**Application by NNB Generation Company Ltd (NNB GenCo)
to carry on radioactive substance activities at
Hinkley Point C Power Station
EPR/ZP3690SY/A001**

Decision document

NNB Generation Company Limited	Hinkley Point C Power Station	Radioactive Substances
--------------------------------	-------------------------------	------------------------

Copy of Figure 10, taken from HPC RSR Submission, Chapter 2.4 on page 63 of 92 with modified colour

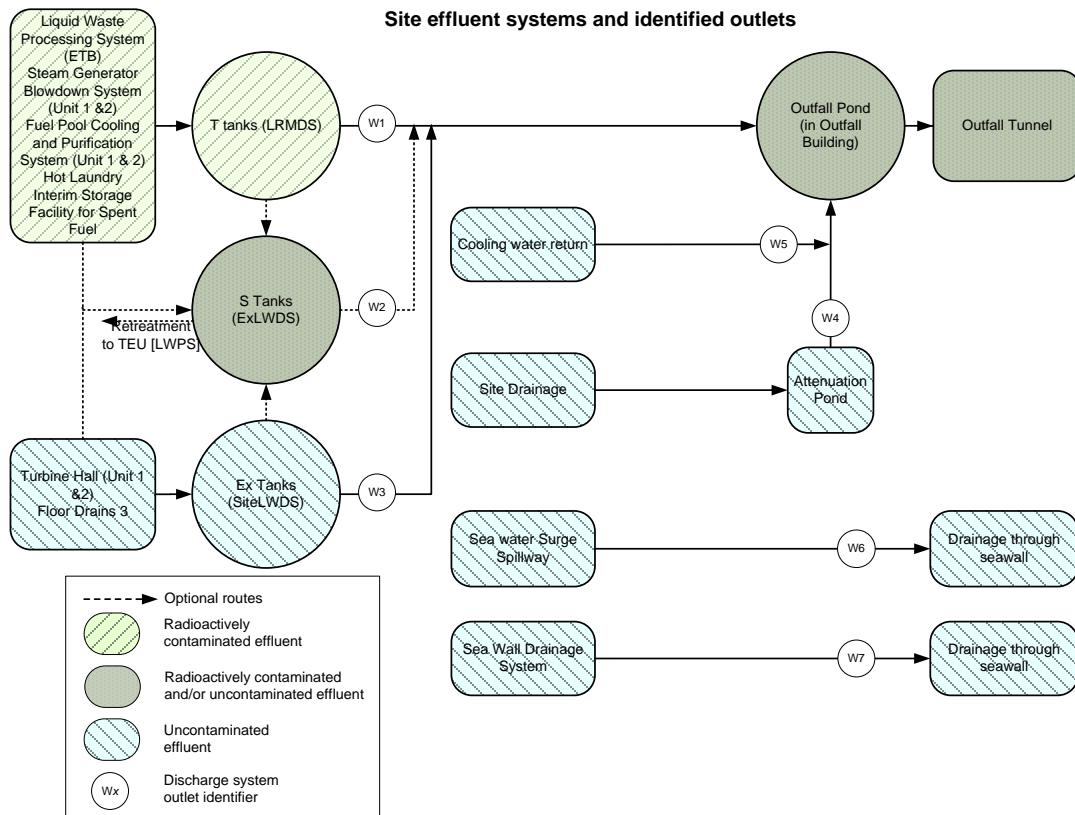
- a) W4 – water run off from car parks and site buildings is collected in the Attenuation Pond. Contamination is unlikely, and the pond discharges through outlet W4 into the Outfall Pond. We noticed some inconsistency between figure 10 and the description of outlet W4 in NNG GenCo's submission. We asked for further information in our second Schedule 5 notice. Our notice is available on our [Hinkley Point webpage](#)⁴⁹ and NNB

311 The Nuclear Free Local Authorities (NFLA) commented, in response to the consultation on our draft decision, that the diagram above was incorrectly coloured and gave a false impression of the fate of aqueous radioactive waste. We reproduced the diagram from NNB GenCo's application; there were subtle colours in the diagram that were unfortunately lost in publishing process. However, as NFLA pointed out, the text was quite clear about the fate of radioactivity and we have amended the colours in the diagram for this document to make it clearer.

GenCo's reply is available on [EDF Energy's website](#)⁵⁰. We concluded that there are, in fact, two outlets and have included them as W4A and W4B in the permit.
